Project	IEEE 802.16 Broadband Wireless Access Working Group < <a href="http://ieee802.org/16">http://ieee802.org/16</a> >	
Title	Service Primitives for Paging Group Action	
Date Submitted	2005-07-11	
Source(s)	Jee Hyeon Na, Yun Won Chung, PhD Sang Ho Lee, PhD ETRI, 161, Gajeong-dong, Yuseong-gu, Daejeon, 305-700, Korea	<a href="mailto:jhna@etri.re.kr">jhna@etri.re.kr</a> <a href="mailto:yun.chung@etri.re.kr">yun.chung@etri.re.kr</a> <a href="mailto:leesh@etri.re.kr">leesh@etri.re.kr</a> Voice: +82-42-860-5408 Fax: +82-42-861-1966
Re:	Call for Comment on P802.16g Baseline Document	
Abstract	This contribution proposes service primitive for paging group action	
Purpose	The document should be considered during the resolution of comments on the baseline document.	
Notice	This document has been prepared to assist IEEE 802.16. It is offered as a basis for discussion and is not binding on the contributing individual(s) or organization(s). The material in this document is subject to change in form and content after further study. The contributor(s) reserve(s) the right to add, amend or withdraw material contained herein.

# Service Primitive for Paging Group Action

Fig. 2 - Paging Group Action Procedures

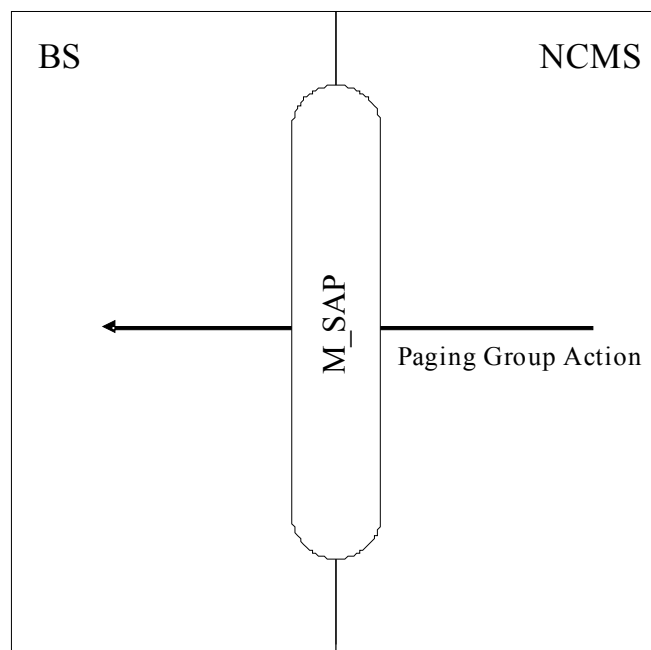
[Modify section 14.5.9.2 as follow]

The location information of an idle MSS is managed by the unit of Paging Group in Paging Service of an NCMS, and paging messages are sent to all the BSs within the called MSS's Paging Group. The NCMS should divide the whole service area into multiple Paging Groups and notify this Paging Group information to all the BSs within the service area, where a BS may be a member of one or more Paging Groups. In this contribution, we propose service primitives for Paging Group Action which are exchanged through Management Service Access Point (M-SAP) of Management Plane specified in IEEE 802.16g baseline document. Paging Group Action is performed by Paging Service of an NCMS, as shown in Fig. 2
